1385 HILLSIDE CIRCLE, (LOT 1) BURLINGAME, CA
A.P.N.: 000-000-000

As requested on December 4th, 2023, Kieilty Arborist Services visited the above site to provide a Tree Inventory Report/Tree Protection Plan for the proposed construction. 3 new homes are proposed for this site, and your concern as to the future health and safety of the tree has prompted this visit. Preliminary landscape plans L1 through L7 dated January 2024, lot 1 site plans A.1 through A.6 dated 10/26/22, lot 2 site plans A.1 through A.6 dated 10/26/21, and lot 3 plans A.1 through A.8 dated 10/26/21 were also reviewed for writing this report. This Tree Inventory Report is not a Tree Risk Assessment. As such, no trees were assessed for risk in accordance with industry standards, nor are there any tree risk ratings or risk mitigation recommendations provided within this preservation plan.

NEW RESIDENCE
1385 HILLSIDE CIRCLE LOT 1
BURLINGAME, C.A.
A.P.N.: 000-000-000

A.1.1

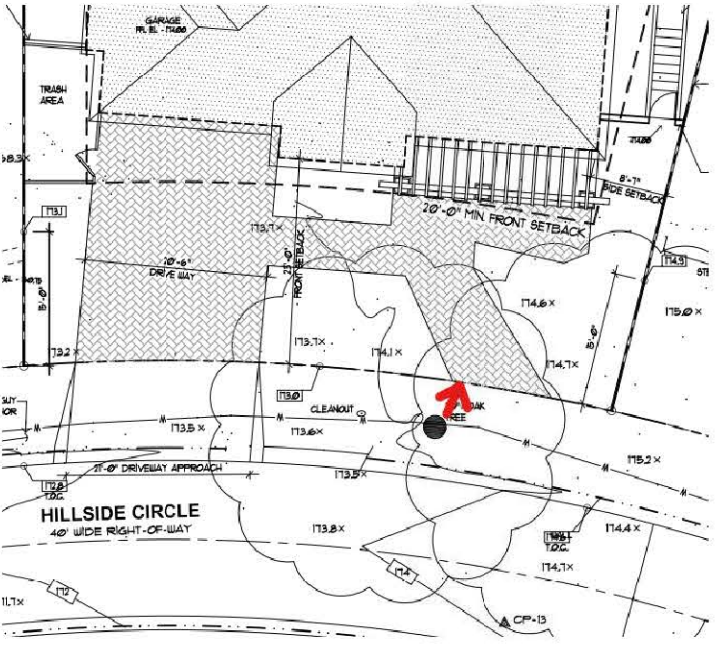
Impacts/Recommendations:
Oak tree #1 is to be retained. The tree is adjacent to an existing driveway. It is recommended to temporarily retain the existing driveway near this tree when underneath the dripline of the tree during the building phase of the project. Temporarily retaining the driveway will act as a tree protection measure and will help to increase staging and access to the site, as removing the driveway at the beginning of the project would make for a larger tree protection zone needed with the fencing being located at the tree's drip line. The existing grade within the tree's dripline is recommended to be retained as is where possible. No grading or excavation is recommended to take place within 10' from this tree (6x diameter) except for the removal of the driveway. At the end of the project, when it is time to demolish the existing driveway near this tree, the Project Arborist is

recommended to be on-site to document and witness the removal of the driveway. A jackhammer is recommended to be used when working within the tree's drip line to break the concrete material into hand manageable-sized pieces. Once broken down the driveway material is recommended to be removed by hand. Exposed roots during the process are recommended to be wrapped in layers of wetted-down burlap to avoid root desiccation. The existing driveway area is recommended to be filled back in once the driveway has been removed so that no roots are exposed to the elements. When backfilling the soil in this area, the area is also to be irrigated. The proposed driveway is further from the tree than the existing driveway and outside of the 10' range and is not expected to have impacts on the tree. The tree is recommended to be deep water fertilized with Nutriroot once the work near the tree has taken place as a mitigation measure for any minor impacts that may take place.

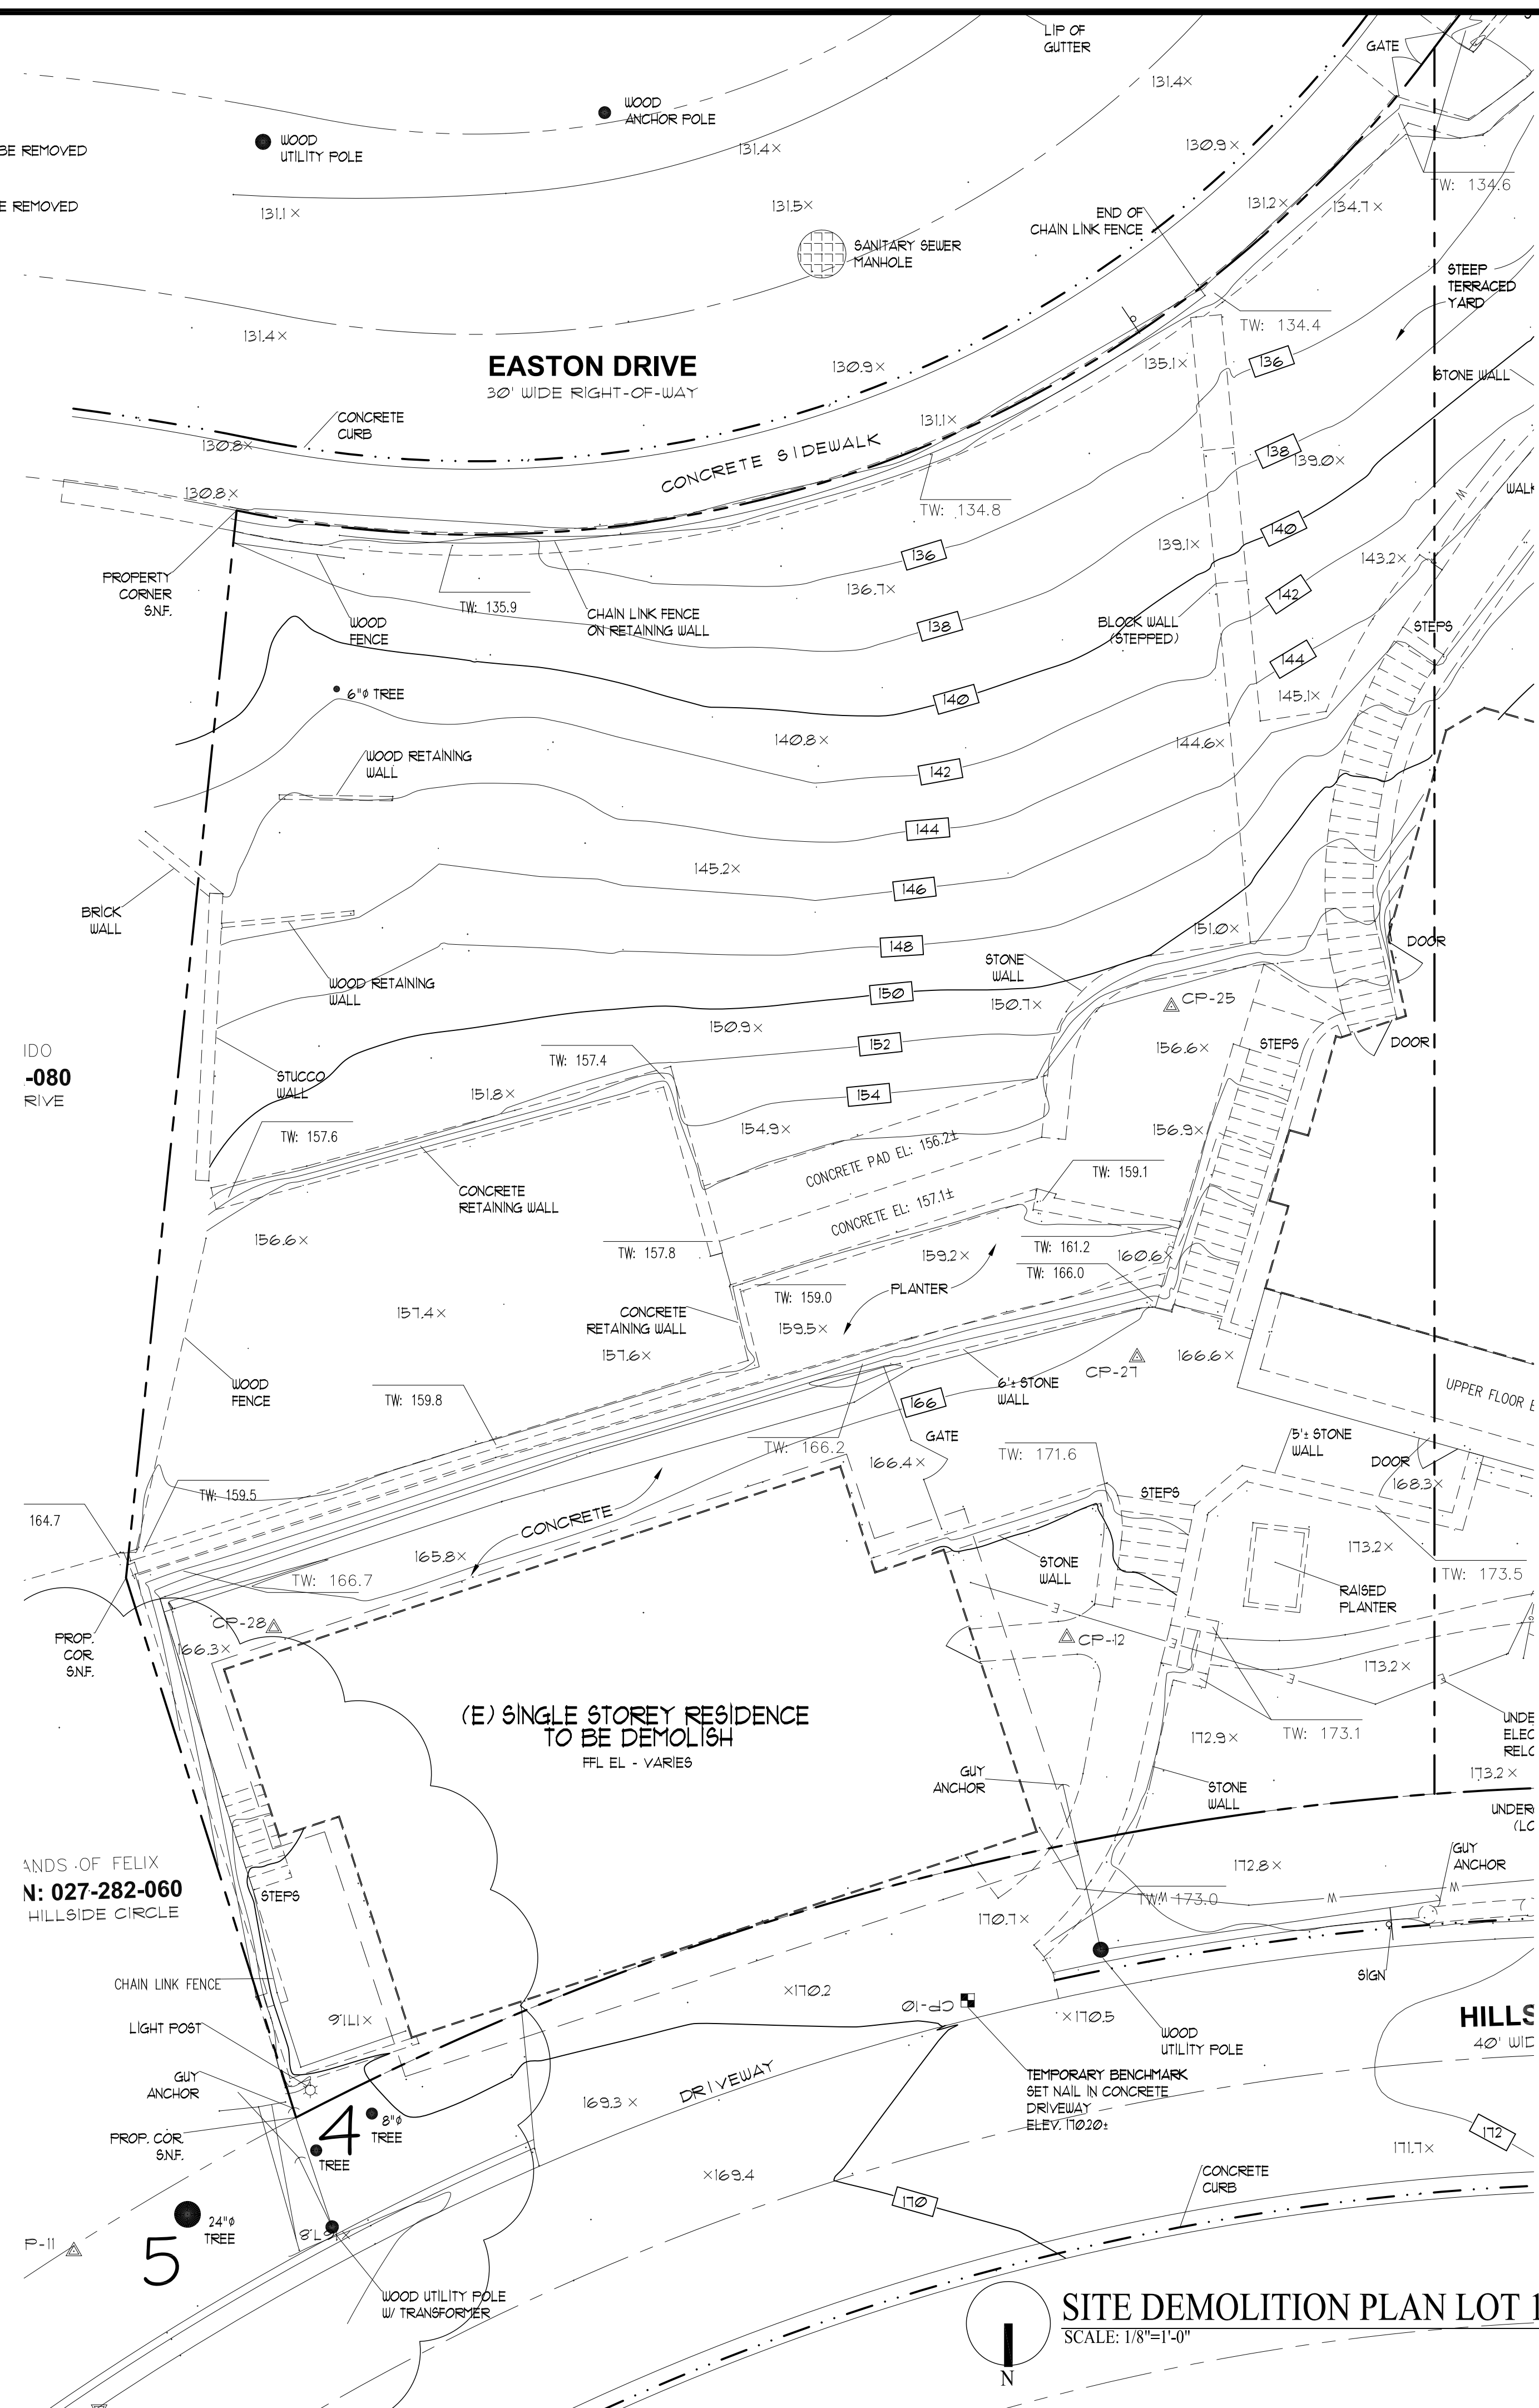
ENSURE THAT TREE PROTECTION SPECIFICATIONS ARE SHOWN GRAPHICALLY ON SITE PLANS FOR CONTRACTOR TO FOLLOW, AS FOLLOWS:

LOCATION OF ALL TREE PROTECTION MEASURES INCLUDING BUT NOT LIMITED TO FENCING, TRUNK WRAP, ROOT BUFFER, ARE TO BE GRAPHICALLY SHOWN ON DEMO PLAN A2 SO THAT CONTRACTOR CAN EASILY INSTALL AND EXECUTE THE TREE PROTECTION MEASURES.

LOCATIONS OF HAND DIGGING AND LOCATIONS OF WORK TO BE UNDER PROJECT ARBORIST SUPERVISION ARE TO BE GRAPHICALLY SHOWN ON THE RELEVANT SITE PLAN SO THAT CONTRACTOR(S) CAN EASILY UNDERSTAND AND EXECUTE THE SPECIFICATIONS. WORK WITH THE PROJECT ARBORIST TO PRODUCE ACCURATE INFORMATION ON THE RELEVANT SITE PLAN. SOME OF THE INFORMATION WILL BE ON THE A SHEETS AND SOME ON THE L SHEETS.

ARBORIST REPORT RECOMMENDS:
RETAINING SOME OF THE DRIVEWAY NEAR TREE 1 AND BREAKING IT DOWN BY HAND LATER IN THE PROJECT. PUT THIS ON DEMO PLAN A2 SO CONTRACTOR CAN FOLLOW IT.
CHANGING THE PATHWAY NEAR TREE 10 TO AVOID ROOT LOSS/DAMAGE. WHERE IS TREE 10? HAS THE PATHWAY BEEN CHANGED?

ARBORIST REPORT IS BASED ON REVIEWING L PLANS DATED JAN 2024, LOT 1 A PLANS DATED 10-26-22, LOT 2 A PLANS DATED 10-26-21 AND LOT 3 A PLANS DATED 10-26-21. NO CIVIL PLANS REVIEWED. NOTE THAT THE CONTENT OF CIVIL PLANS MAY NECESSITATE A CHANGE IN THE ARBORIST RECOMMENDATIONS.

PROVIDE THE BOTANICAL NAME (GENUS AND SPECIES) AND LOCATION OF THE REQUIRED LANDSCAPE TREES, AND WHETHER THEY ARE EXISTING OR NEW FOR EACH LOT.
